Rolling Knolls Landfill Superfund SITE
FIELD CHANGE REQUEST (FCR) FORM

REQUEST NO: 08

DATE: 06/09/2015

FCR TITLE: Replacement of MW-13 with Pore-water Samplers

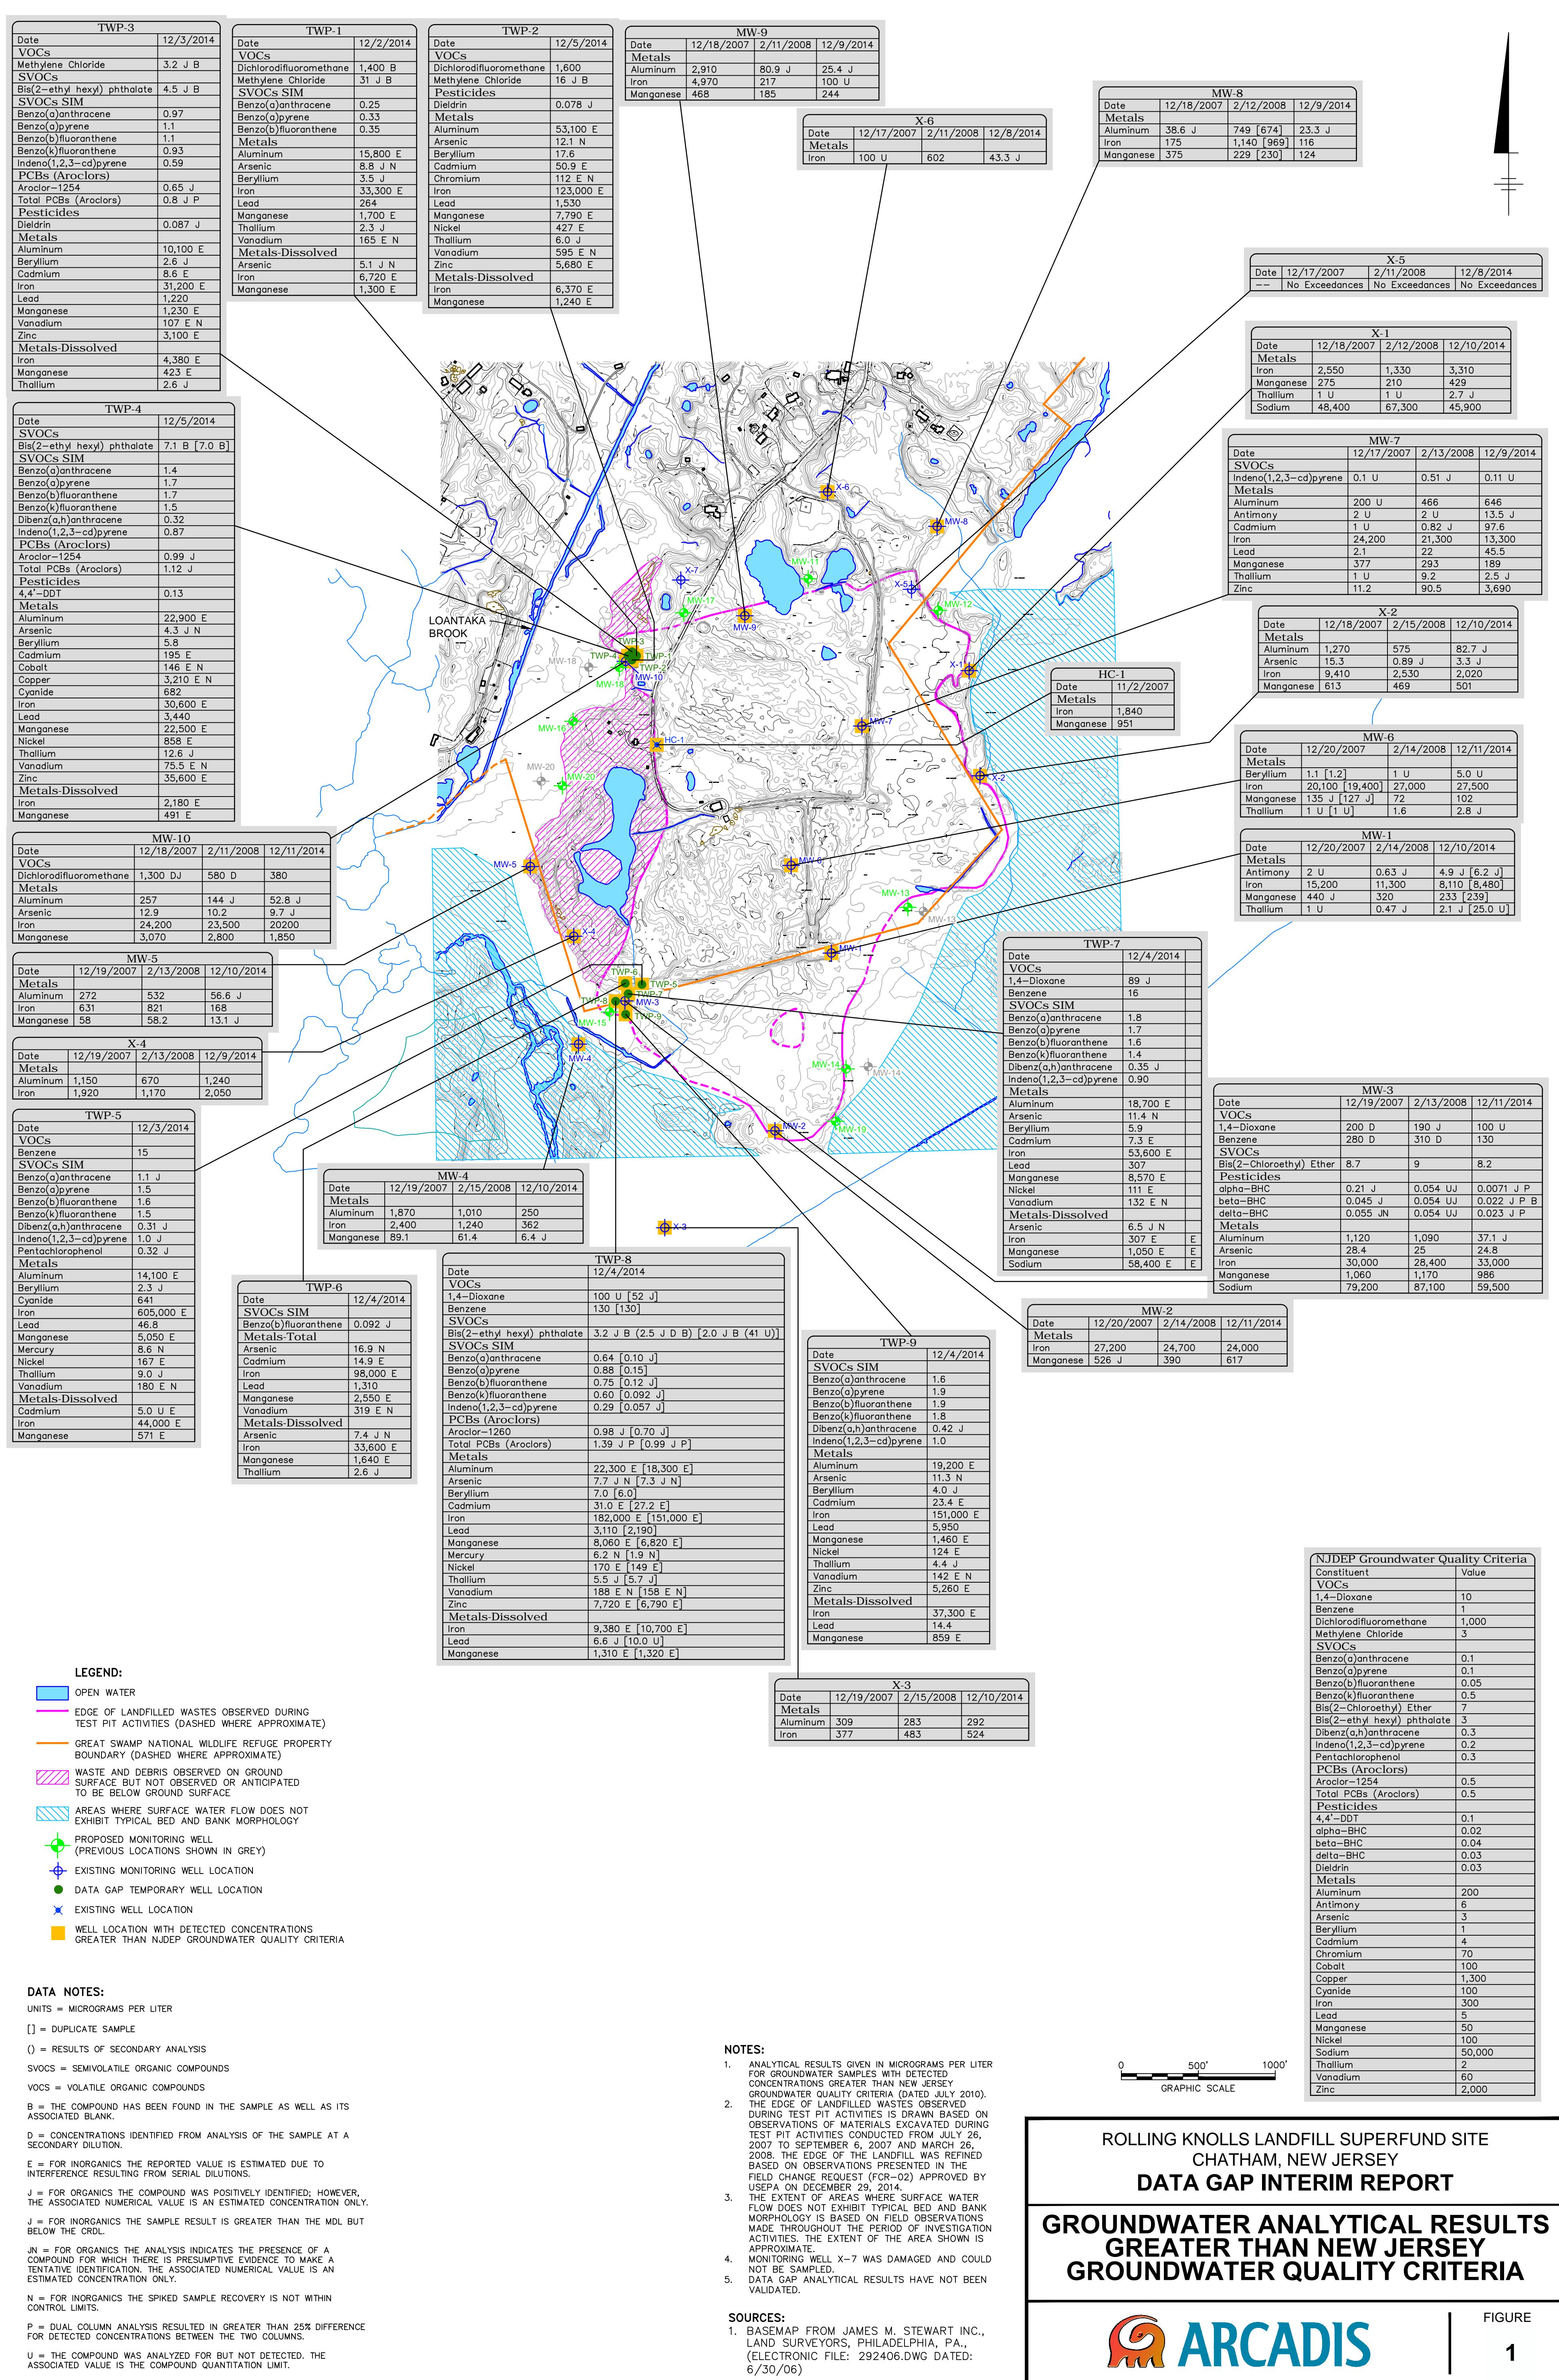
The purpose of MW-13 is to provide “monitoring in vicinity of PCBs detected in soil samples SS-157 and SS-158.” Based on the attached figure with the new proposed location, it is not clear how this location will monitor the PCBs in the targeted soil area.

Attached is a figure showing the proposed location. The condition at the original location (shown in grey) was previously dry enough for well installation but is currently under 6 to 12 inches of standing water. The field crew and CDM representative had to move approximately 150 feet west, into the landfill, in order to find the nearest dry location.

Can you provide some additional detail of the proposed new location for MW-13? Where are you proposing to move the MW from the location identified in FCR-06? This information will be helpful to determine if a FCR is needed.

I spoke with the field crew this evening and have been informed that two monitoring well locations (MW-13 and MW-14) previously adjusted in FCR-06 (approved on April 27, 2015) are now located in standing water. The crew identified alternative locations for these two wells. The CDM representative was present during these evaluations.
